Interactive comment on “Brief communication: Improved simulation of the present-day Greenland firn layer (1960–2016)” by Stefan R. M. Ligtenberg et al.

Dear editor and reviewers,

We would like to thank the two reviewers for their positive and constructive comments, which improved the manuscript. Our response to the comments is point-by-point and when text in the manuscript was changed/added it is provided in quotes. The updated Figures 1 and 3 are given at the end of the responses.

Fig. 1. Revised Figure 1

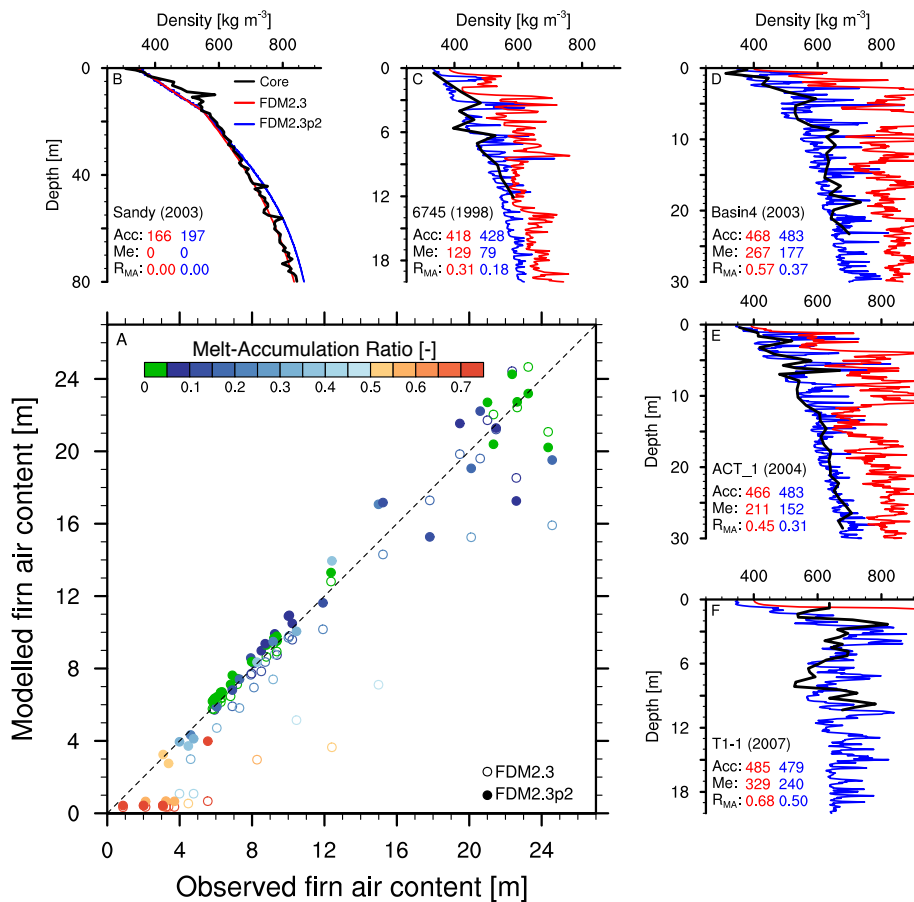
P3L13-14+Fig 1: You discuss the three categories of the melt-accumulation ratio and Figure 1 has this quantity color-coded. But it is tricky to read off the colorbar. I suggest you choose a colorbar with three color-sets (eg. greens, blues and reds) that shifts exactly with the three categories. Response: changed the colour bar.

Fig 1 caption: Note that modeled profiles are taken at same time as the cores were drilled. Perhaps indicate on the profiles when this is. Response: Added the year when the cores were drilled.

Figure 1: - I think that instead of referring the reader to another paper to find the site locations, you could include them (the 5 plotted here, at least) on one of the panels in figure 3. Response: Added the 5 locations and names in Fig 3A.

- I know space is tight but having labels for the rows of numbers in the subpanels would be very useful to me. They could be as simple as b_{dot} , m_{dot} , and $m_{\text{dot}}/b_{\text{dot}}$. Response: Added "Acc", "Me", and RMA for clarity.

- Since you have divided the firn into 3 regions (dry, moderate melt, high melt) it may be useful to choose a colormap that has 3 distinct zones, or to at least mark on the colorbar where the transitions between zones are. Response: changed this.

- Since FAC is the metric you are looking at elsewhere, consider changing panels b-f to show FAC as a function of depth rather than density. Response: Here, FAC is only used as a metric to describe the entire firn column with one value. Also a figure showing a vertical profile of $FAC(z)$ is probably more difficult to interpret for readers. Therefore, we decided to keep these panels as is.

Fig. 2. Revised Figure 3

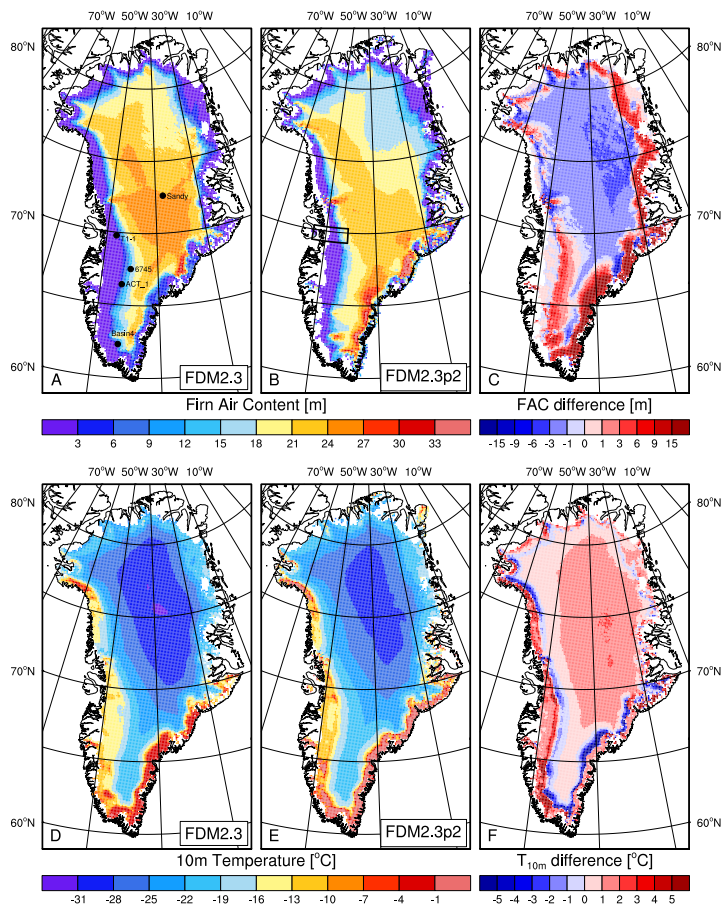
Fig 3 caption: “Difference between” can sometimes be a bit unclear. Please indicate exactly what is subtracted from what. Response: Done

Figure 3: - The color scale for the difference plots is a bit challenging because it is not linear; it does not clearly demonstrate your point that the biggest changes in FAC are in the moderate melt zone because the interior has some dark blue, but that is not nearly the magnitude of the red it turns out. Response: changed the color scale of Fig 3C. Now, the red in the southeast is clearly darker than the blue in the interior.
